BACK RIVER GOLD MINE PROJECT 2025 ANNUAL REPORT: RESPONSES TO REVIEW COMMENTS

RESPONSES TO REVIEW COMMENTS

12MN036

Figure 1: FIRE MAP Historical Aerosol Index Data Screenshot – July 18, 2025

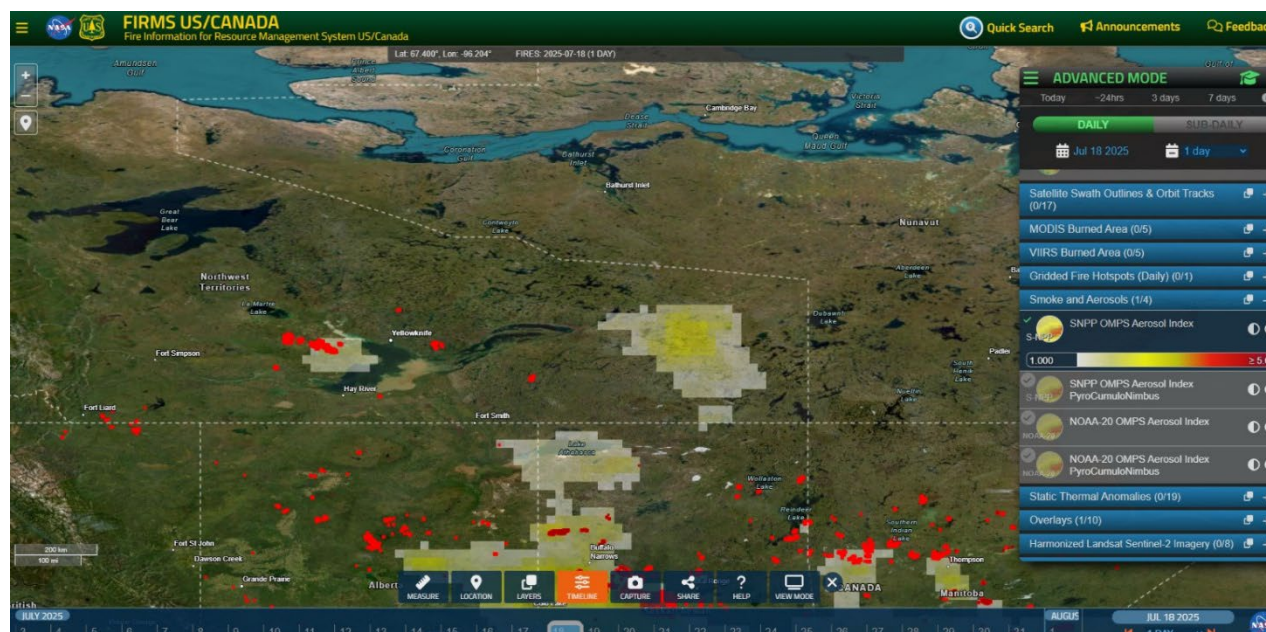
- **July 18, 2025, exceedance:**
 - The FIRE MAP showed a substantial smoke plume in eastern NWT, directly south of the Project (Figure 1 below). Looking at the Worldview Snapshots imagery on that day, wildfire smoke can be seen near the project, although there is significant cloud cover above the Project making it difficult to see the smoke at the actual Project location (Figure 2 below). This cloud cover may explain why the OMPS aerosol index data did not show a plume above the Project that day.

Figure 3: FIRE MAP Historical Aerosol Index Data Screenshot – July 30, 2025

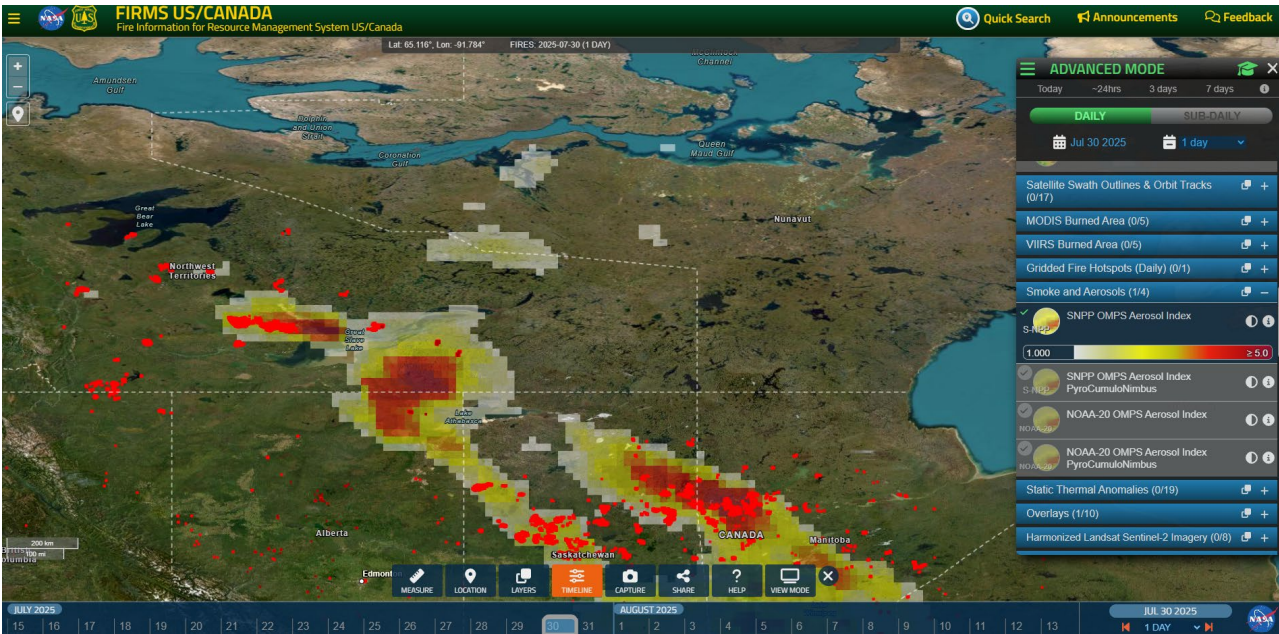
- **July 30, 2025, exceedance:**
 - The FIRE MAP showed substantial smoke plumes in western Nunavut around the Project (Figure 3 below). The Worldview Snapshots imagery clearly shows smoke where the Project is located (Figure 4 below).

Figure 5: FIRE MAP Historical Aerosol Index Data Screenshot – July 31, 2025

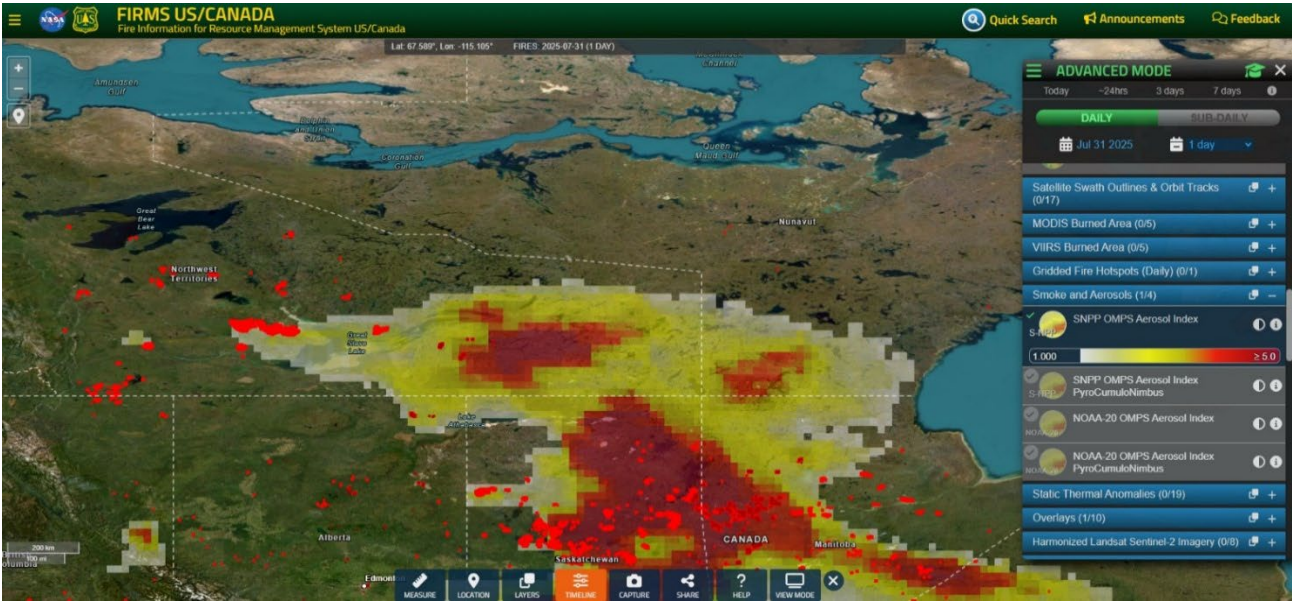
- The FIRE MAP showed the previous day's smoke plumes converging together further south in eastern NWT south of the Project (Figure 5 below). The Worldview Snapshots imagery shows smoke over eastern NWT south of where the Project is located (Figure 6 below).

Figure 7: FIRE MAP Historical Aerosol Index Data Screenshot – August 5, 2025

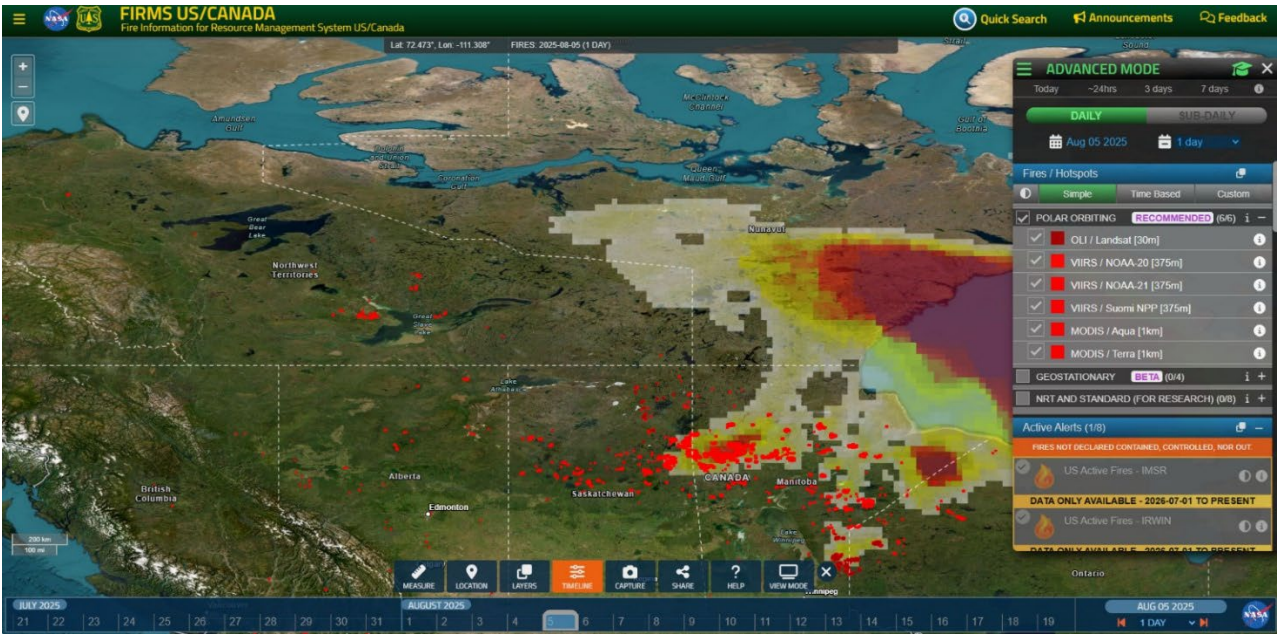
- **August 4-5, 2025, exceedances:**
 - The FIRE MAP showed substantial smoke plumes in eastern NWT south of the Project on August 4 and over the Project on August 5 (Figure 7 below). Both August 4th and 5th Worldview Snapshots imagery are obstructed by cloud cover, however, smoke can be seen in eastern NWT right up to its northern border with Nunavut on August 4 (Figure 8 below).

Figure 10: Worldview Snapshot – September 2, 2025

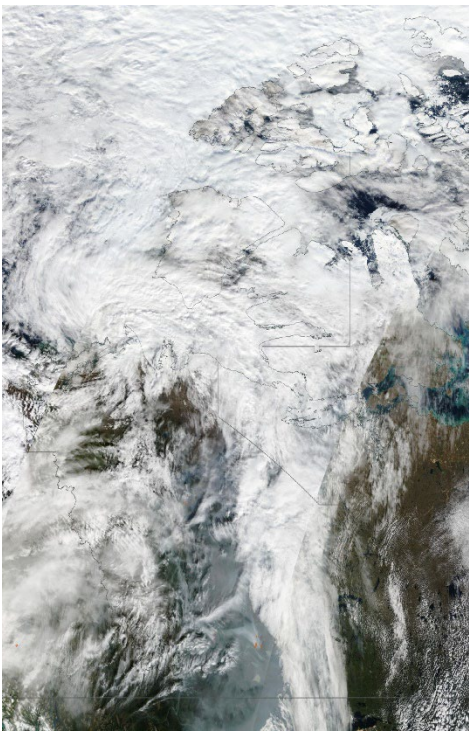
- **September 3, 2025, exceedance:**
 - The FIRE MAP does not show any plumes on September 3 based on OMPS Aerosol Index data, however, the day prior, there are scattered plumes near Bathurst Inlet (Figure 9 below). The Worldview Snapshots for September 3 is obstructed by heavy cloud cover, but the imagery from September 2, shows wildfire smoke in the NWT up to the northern Nunavut border where cloud cover obstructs it (Figure 10 below).

Photo 1: Damaged Liner NW Corner of Tank Farm 1

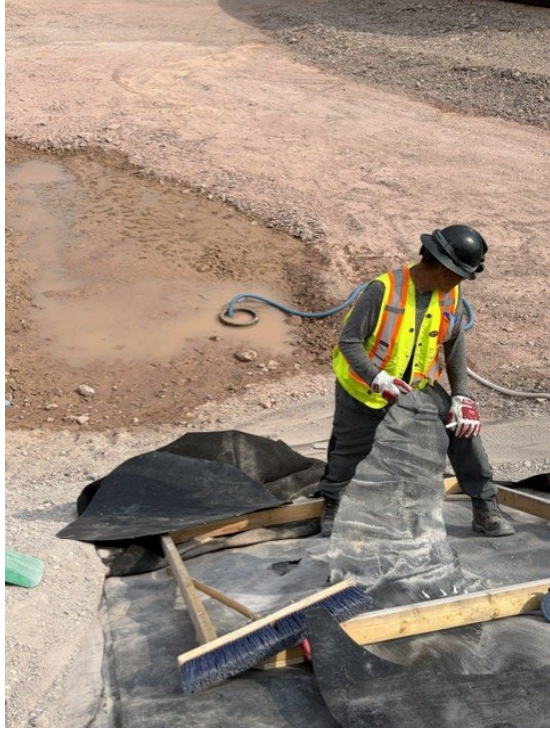
- **Item 4** – Liner damage and erosion at Goose and MLA tank farms: B2Gold can confirm that For the MLA fuel tank farm, HDPE liner repairs were completed under Ramp 1 (main tank farm exit), including removal and replacement of damaged liner and geotextile, installation of new textured 60-mil HDPE panels, QA/QC testing of welds, and issuance of a one-year installation warranty dated June 30, 2026. These repairs also included patch work on the east side of Tank 5 and near the NW corner sump (photos below). Detailed are provided in in Appendix KIA 51_TC13. For the Goose tank farm, discussion and evaluation are ongoing and updates will be provided when the work is complete.

Photo 2: Exposed HDP Liner NW Corner was fixed and tested
